**KING CITY PLANNING COMMISSION
MEETING**

To consider Case No. LU 18-03 (Northwest corner of SW 131st Avenue and SW Fischer Road), Zone Change, Subdivision, Tree Removal, and Goal 5 Safe Harbor Review.

MEMORANDUM

TO: King City Planning Commission
FROM: Keith Liden, Planning Consultant
SUBJECT: SW 131st/Fischer Zone Change and Subdivision Staff Report - File No. LU 18-03
Zone Change and Subdivision Application
DATE: November 28, 2018

Re: Case #LU 18-03 NW Corner of 131st Ave and SW Fischer Rd

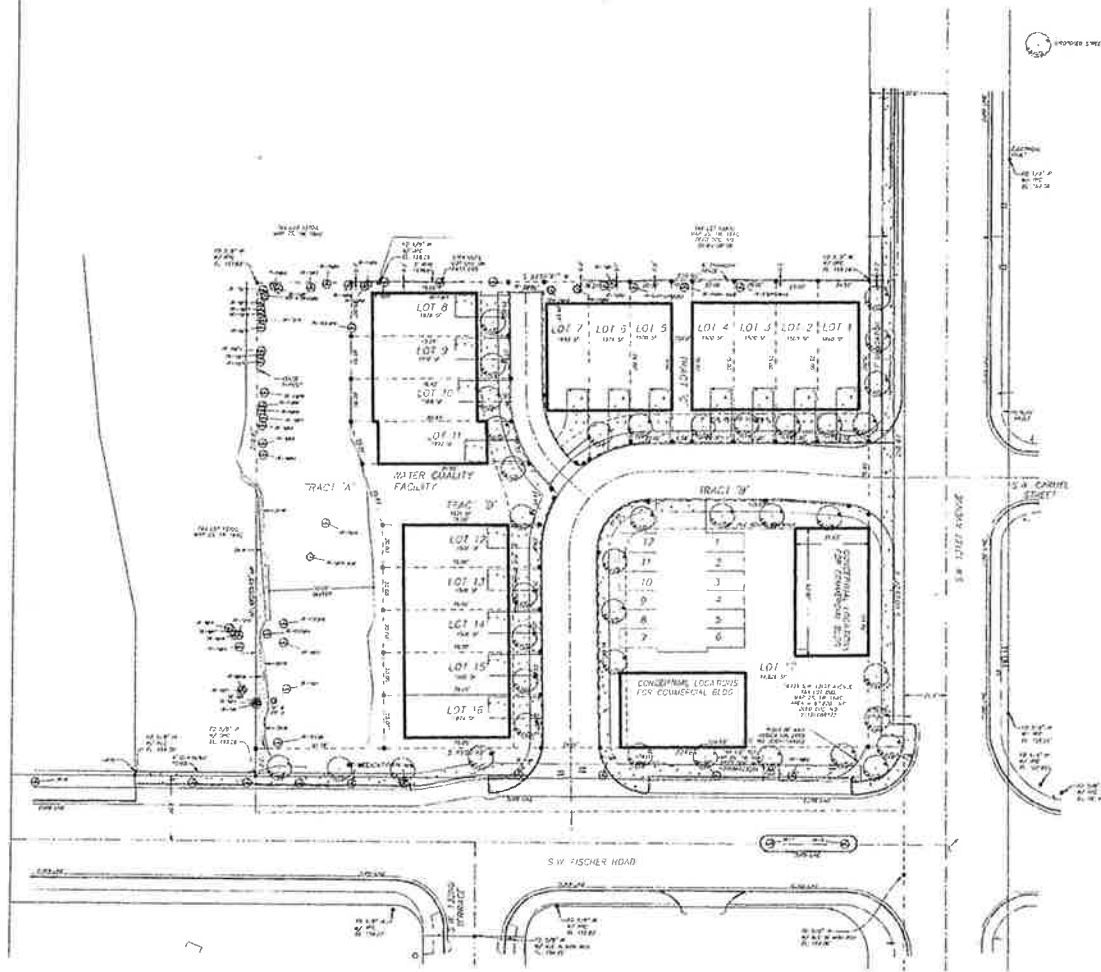
We have reviewed the site plan for the above mentioned development. We will be able to service the development as it's been laid out. All residents will need to bring their receptacles to the nearest public road. With the exception of lots 8 thru 11, if the street is marked for no parking they will be able to put their receptacles curbside for service. If it is not marked for no parking then they will need to bring their receptacles to the nearest public road.

We are not approving the commercial concept at this time, we will need to see and review the enclosure prior to giving an approval letter.

SHEET TITLE: PRELIMINARY PLAT
SHEET NUMBER: P4

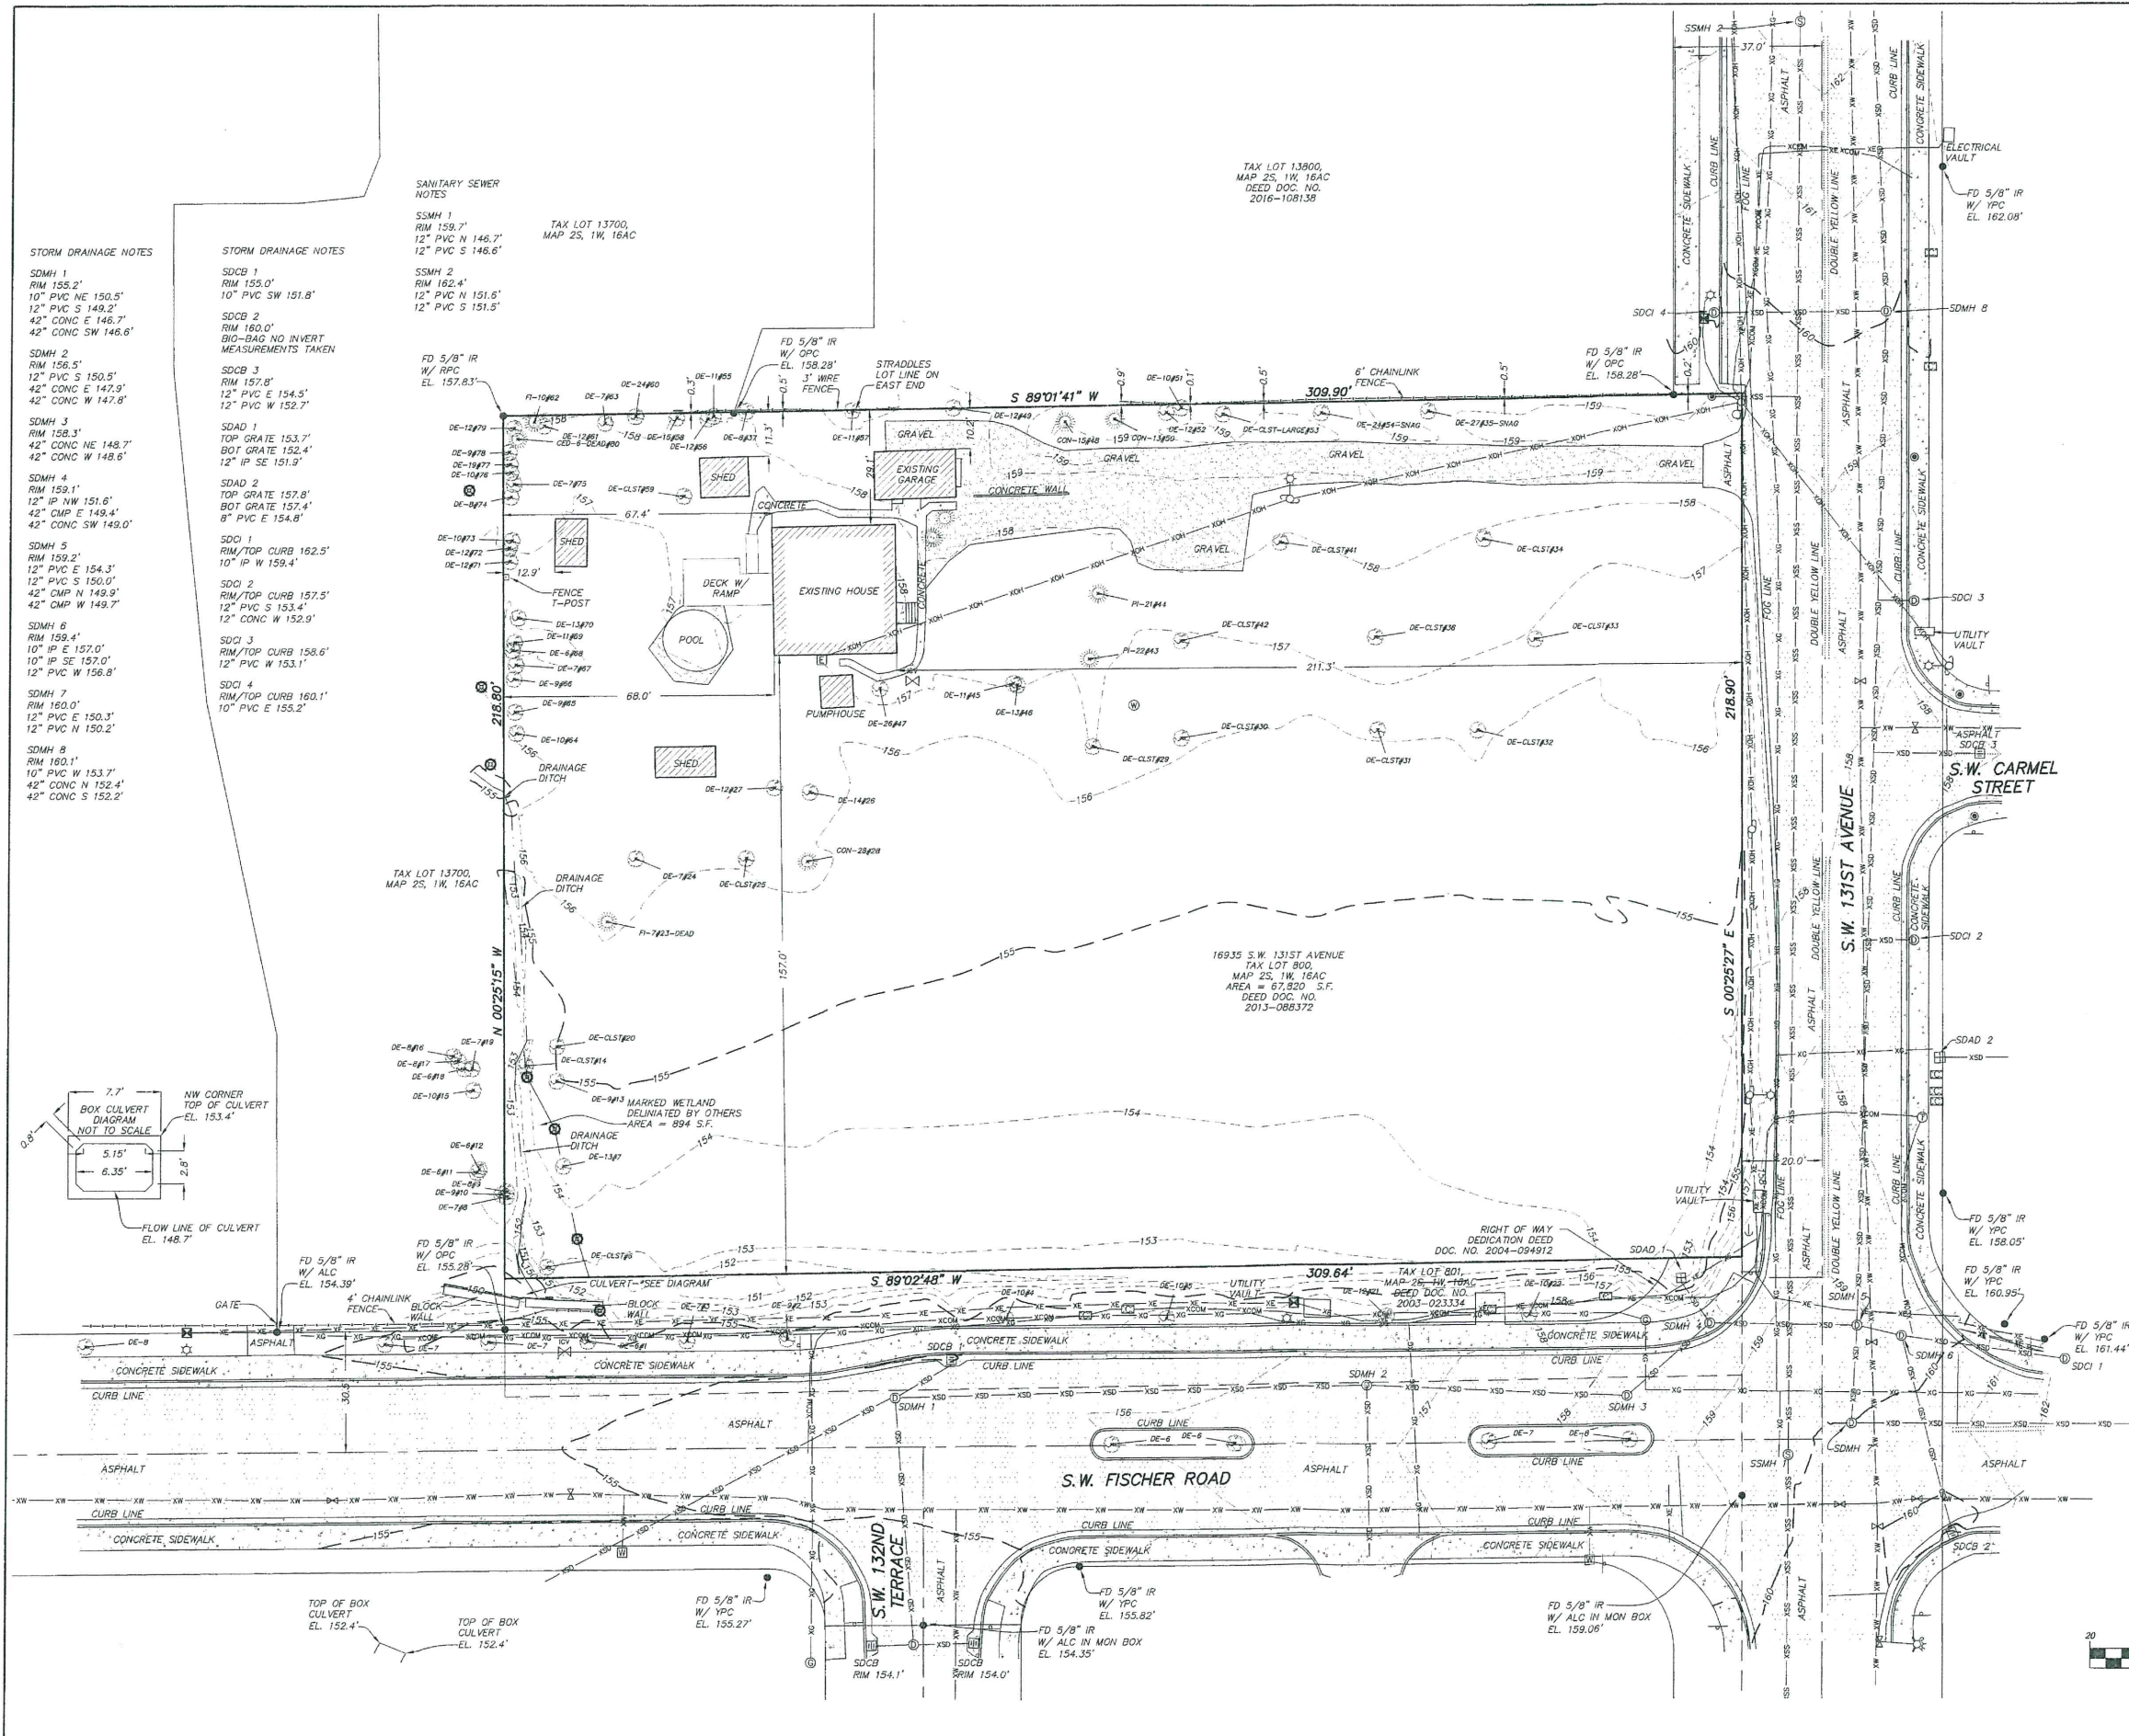
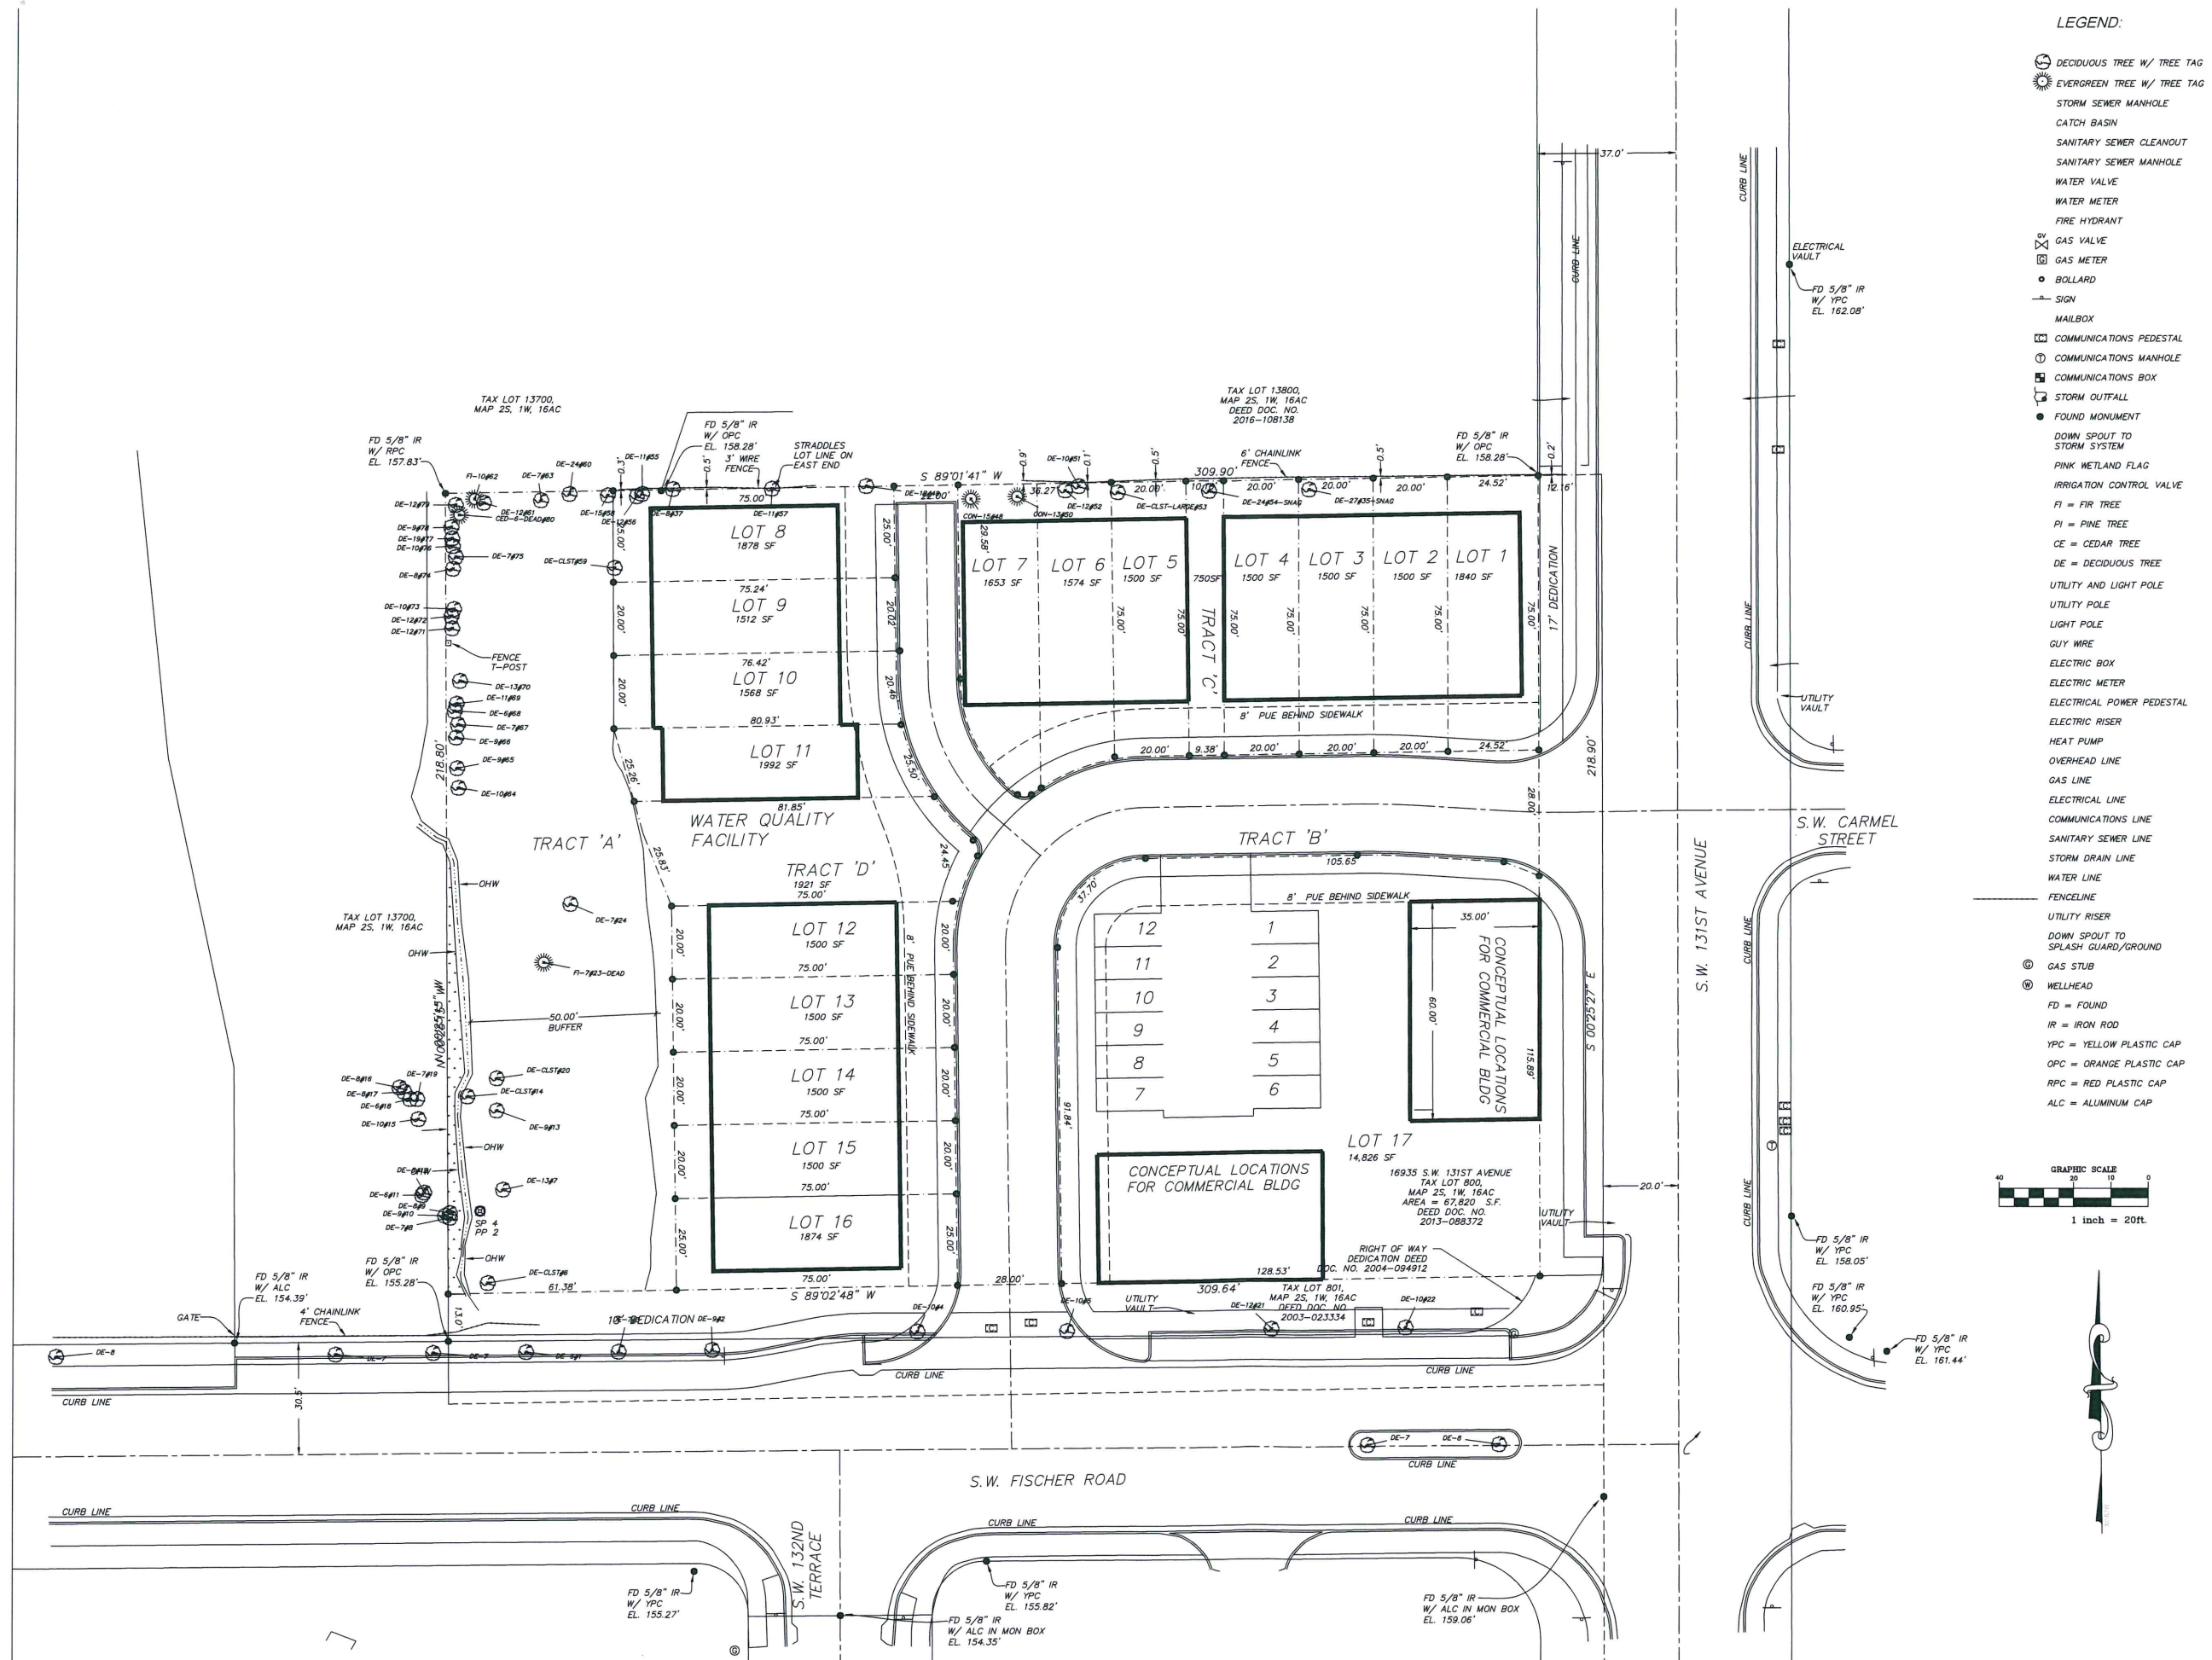
The landscaping plan (Exhibit 8 Plan Set, Sheet P4) includes trees along the private street frontages within the development and along SW 131st Avenue and SW Fischer Road. Section 16.124.060 requires yard trees have an average spacing of 25 to 40 feet, depending upon the mature size of the tree. Trees are shown with spacing of 20 to 30 feet. However, the plan does not indicate a proposed tree species. The tree species and spacing should be reviewed as a condition of approval to ensure appropriate street tree selection and planting. Landscaping for Lot 17 shall be reviewed as part of a future site development review application.

The applicant proposes to provide a one-car garage for each unit. Although house plans have not been provided, the landscaping plan (Exhibit 8 Plan Set, Sheet P4) suggests that each townhome is envisioned to have a recessed garage door, providing sufficient room to park an additional vehicle in the driveway with sufficient room to not block the sidewalk (18-foot garage setback is required from the edge of the sidewalk). In addition, it appears that approximately 8 on-street parking spaces will be possible on the internal street, plus 8-9 parallel spaces along the SW 131st Avenue and SW Fischer Road frontages. Required parking for development on Lot 17 will be determined as part of a future site development review application. Comments have not been received from Tualatin Valley Fire and Rescue (TVFR). However, in the review of previous subdivisions, TVFR consistently has not allowed parking on one side of a two-way street that is less than 28 feet wide. The applicant will either need to remove parking on one side or widen the street to a curb-to-curb minimum of 28 feet.
